November 2, 2016

**Reference: Sunoco Pipeline L.P. – Pennsylvania Pipeline Project
Act 167 Stormwater/Floodplain Management Program Consistency Request-
UPDATED Project Workspaces**

FEMA NFHL Designated Floodplains along the Sunoco Pennsylvania Pipeline Project

Sheet 15 Scale 1:2400

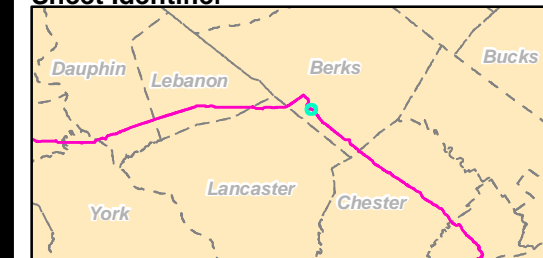
On behalf of Sunoco Pipeline, L.P., Tetra Tech, Inc. is writing to provide updated workspaces/floodplain maps associated with the Pennsylvania Pipeline Project (Project) in Cumru Township as part of our Chapter 105 Water Obstruction and Encroachment Permit Application and request for Act 167 Stormwater/Floodplain Management Consistency Request. Similar to our previous requests on November 10, 2015 and February 8, 2016, we are continuing to seek a consistency determination from Cumru Township in regard to the local Floodplain Management and Stormwater Management Program pursuant to 25 Pennsylvania Code, Chapter 105 Regulations (Sections 105.14(b)(9), 105.13(e)(1)(v-vi)), and under the Stormwater Management Act (32 P.S., §§ 680.1—680.17), respectively. Attached is the latest Project mapping identifying the updated Project workspaces in the Township. The updated workspaces are highlighted as additions and subtractions. Note additional workspaces are shown on Sheets 15, 16, 19, and 20.

Sheet 19 **Scale 1:2400**

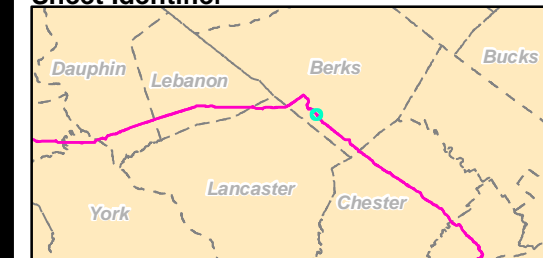
Consistent with the letters we previously sent, no aboveground facilities or new access roads are proposed in FEMA designated floodways or 100-year floodplains. A small portion of the shifted workspace (on Sheet 19) would be located within a 100-year floodplain. However, this workspace (an existing road) would be used for access during construction, and no fill or permanent aboveground structures would be installed in this workspace. No other newly added workspace is located within a floodway/floodplain.
